Final Report

Alaskan Way Viaduct Independent Technical Review

Prepared for
Seattle Department of Transportation

April 10, 2015

FIGURE 3-12
Structural Settlement – Bents 73 to 88 (From As-Built Elevation to March 2015)

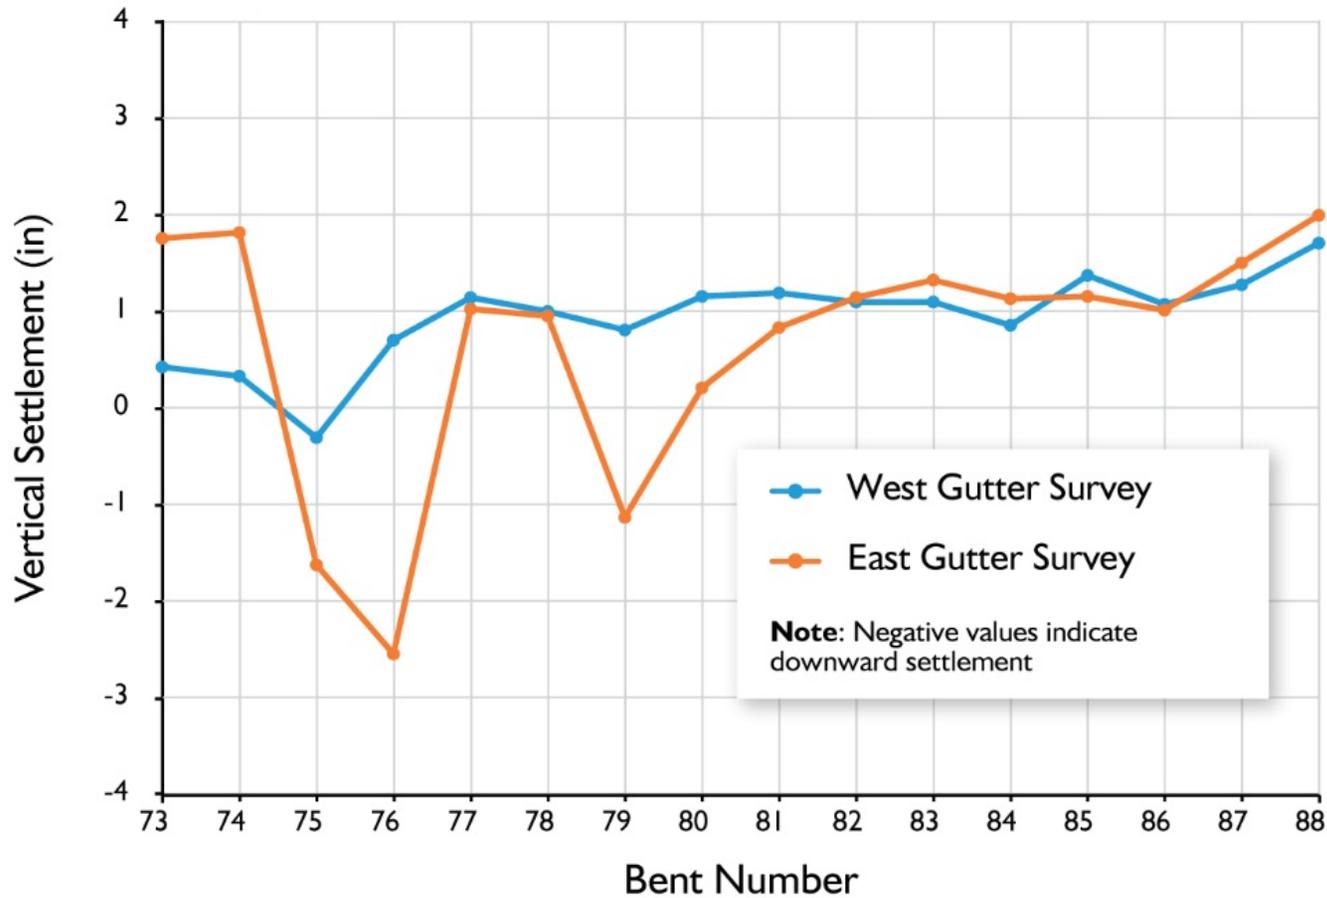
Significant historical settlement has been observed near Bents 75 and 76, as Figure 3-12 shows. Specifically, it was reported by WSDOT that the east footing of Bent 76 appeared to have settled 2.7 inches, while the east footing of Bent 75 appeared to have settled 1.8 inches. WSDOT also reported that the east footing of Bent 79 had settled 1.3 inches. It is understood that cracks were discovered in the upper west column of Bent 76 during a recent WSDOT inspection in March 2014. As a result, WSDOT performed a structural settlement analysis for the three span frame between Bents 73 and 76. Based on the results of the analysis, WSDOT repaired the upper west column of Bent 76 in 2014 using epoxy injection.

CH2M HILL's review of available survey data found that the viaduct structure experienced significant differential settlement in the area between Bents 74 and 76. The maximum magnitude of vertical differential settlement appears to be in excess of 3 inches according to gutter line survey. This magnitude matches relatively well with the settlement reported by WSDOT (2.7 inches). The magnitude of horizontal differential settlement could not be determined as no horizontal survey data were available.

WSDOT's settlement analysis focused on the upper west column at Bent 76, since this is the location where the most significant cracking was observed. The analysis computed capacity-to-demand ratios for flexure and shear in the column and the results suggest that the column has adequate capacity to resist settlement-induced stress. The lowest capacity-to-demand ratio reported was 1.22, with 1.0 usually considered as the minimum for adequate capacity. CH2M HILL's review found the overall analysis approach to be reasonable and the calculations appear to be conservative. However, the analysis did not explain why the column exhibited significant signs of cracking at these relatively low demand levels. Moreover, the analysis did not examine the effect of settlement on rest of the members in the frame.

Considering the magnitude of observed differential settlement in this area, it is recommended that this portion of the viaduct be actively monitored. The settlement assessment should also be expanded to include structural members other than columns. At a minimum, exterior longitudinal girders and

crossbeams, which appear to be the most vulnerable members based on the analysis performed for similar frames between Bents 91-100, should be examined to establish their safety margin.
